APPLICATION NO.	FILING DATE	FIRST NAMED INVENTOR	ATTORNEY DOCKET NO.	CONFIRMATION NO.
10/597,506	10/05/2007	Masakazu Komatsu	0666.2940000	2138
26111 7590 02/04/2010 STERNE, KESSLER, GOLDSTEIN & FOX P.L.L.C.			EXAMINER	
1100 NEW YO	RK AVENUE, N.W.	KNUTSON, JACOB D		
WASHINGTO	WASHINGTON, DC 20005		ART UNIT	PAPER NUMBER
			3611	
			MAIL DATE	DELIVERY MODE
			02/04/2010	PAPER

Application No.	Applicant(s)			
Office Action Summary		10/597,506	KOMATSU ET AL.			
		Examiner	Art Unit			
		JACOB KNUTSON	3611			
	The MAILING DATE of this communication appears on the cover sheet with the correspondence address Period for Reply					
A SHORTENED STATUTORY PERIOD FOR REPLY IS SET TO EXPIRE 3 MONTH(S) OR THIRTY (30) DAYS, WHICHEVER IS LONGER, FROM THE MAILING DATE OF THIS COMMUNICATION. - Extensions of time may be available under the provisions of 37 CFR 1.136(a). In no event, however, may a reply be timely filed after SIX (6) MONTHS from the mailing date of this communication. - If NO period for reply is specified above, the maximum statutory period will apply and will expire SIX (6) MONTHS from the mailing date of this communication. - Failure to reply within the set or extended period for repl

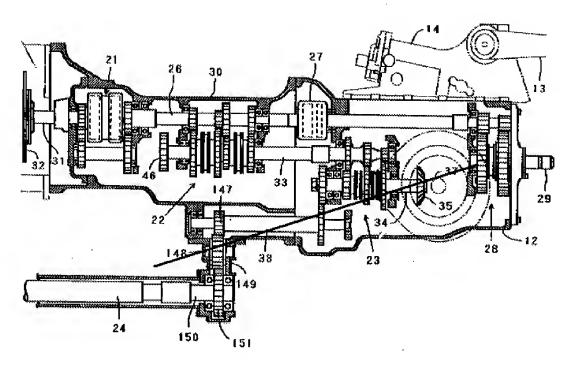
Applicant's arguments filed 9/4/09 have been fully considered but they are not persuasive. The applicant argues the prior art does not recite the limitation "the output shaft of the transmission casing and an input shaft of the gear casing are arranged on a same line and connected to each other". Furthermore, the applicant tries to argue the point by stating the output shaft and input shaft, as mentioned above, are arranged parallel to each other but on a separate parallel line. However, nowhere in the claim does it state the line has to be parallel to the output shaft and input shaft. It is further pointed out where a line exists between the output shaft and

input shaft in the image

below.

Furthermore, the output shaft and input shaft are connected via gear 149, gear 147, and intermediate shaft 38.
